## ORIGINATION FORM

Proposed Revisions to a Standard Plans Index  
(Please provide all information — Incomplete forms will be returned)

Index Number: 630-010  
Sheet Number (s): 1 of 4  
Index Title: Conduit Details - Embedded

INDEX 630-010	SHEET 1 of 4
------------------	-----------------

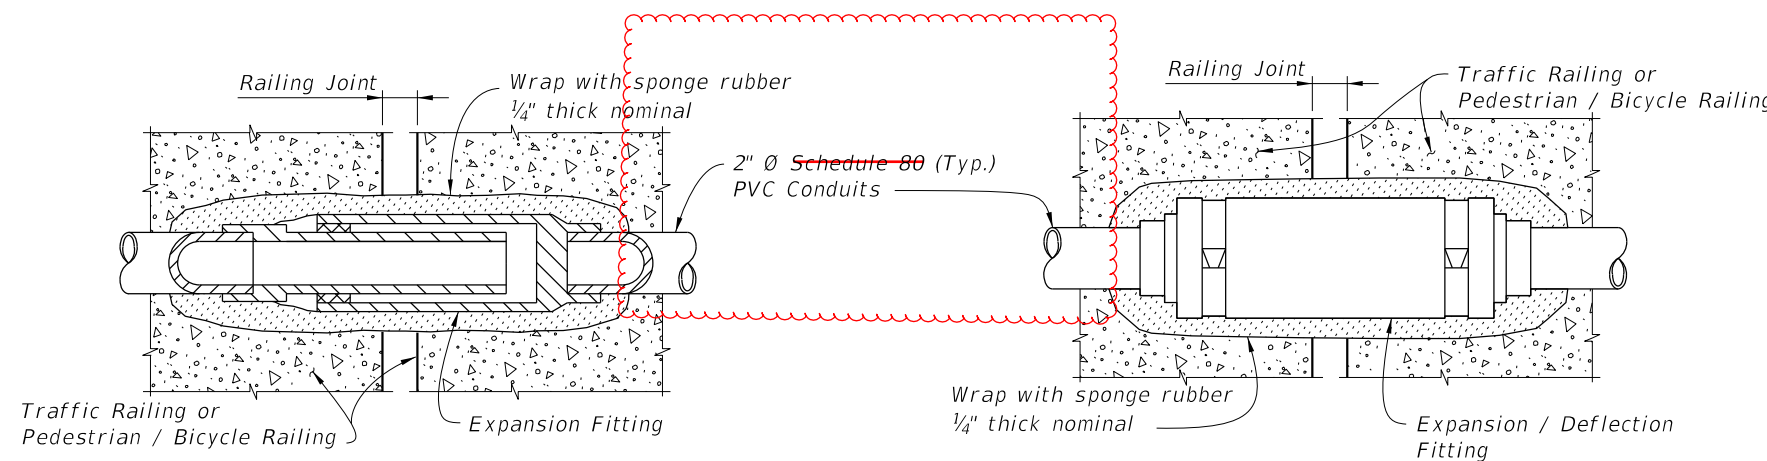
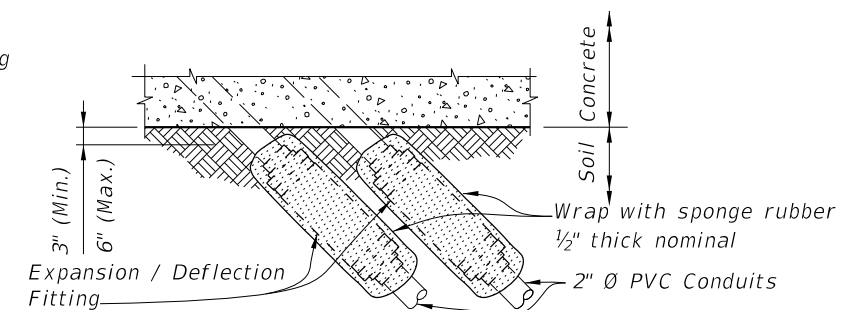
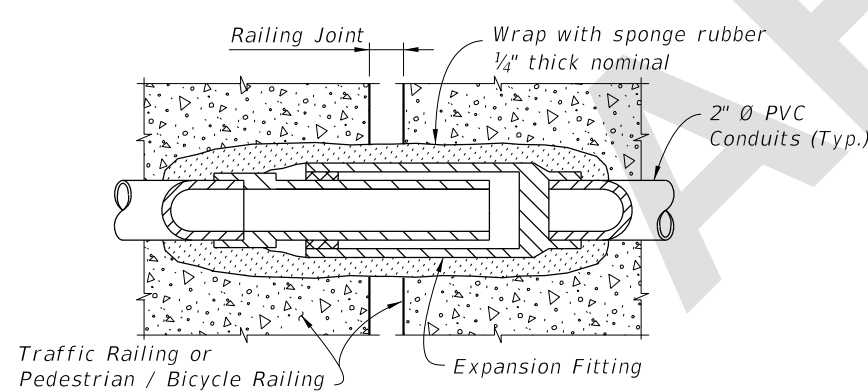
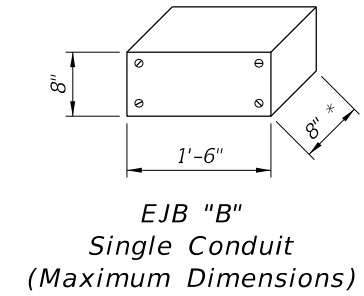
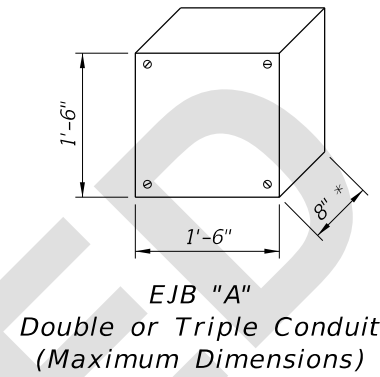
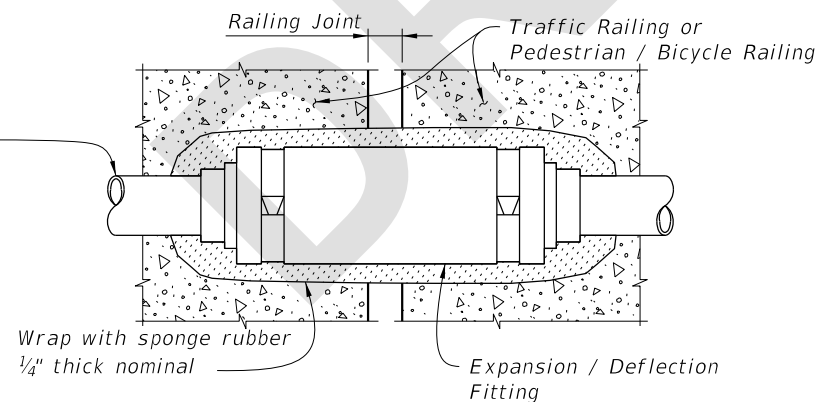
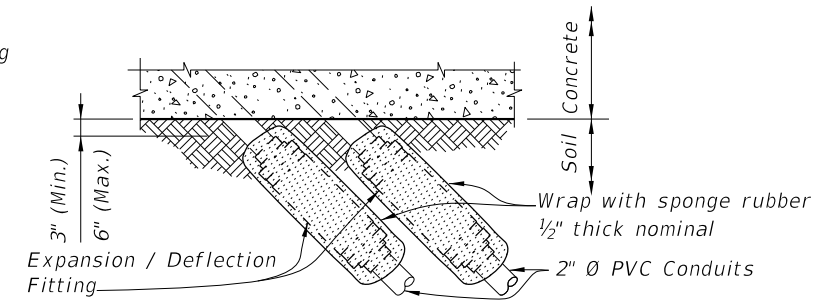
Sheet 1: Revised conduit call out to remove material specification.

Districts agreed with the proposition at the December 2022 TAG meeting to move from Sch 80 to Sch 40. It was decided to remove the material requirements from the Standards as they should be in the Spec.
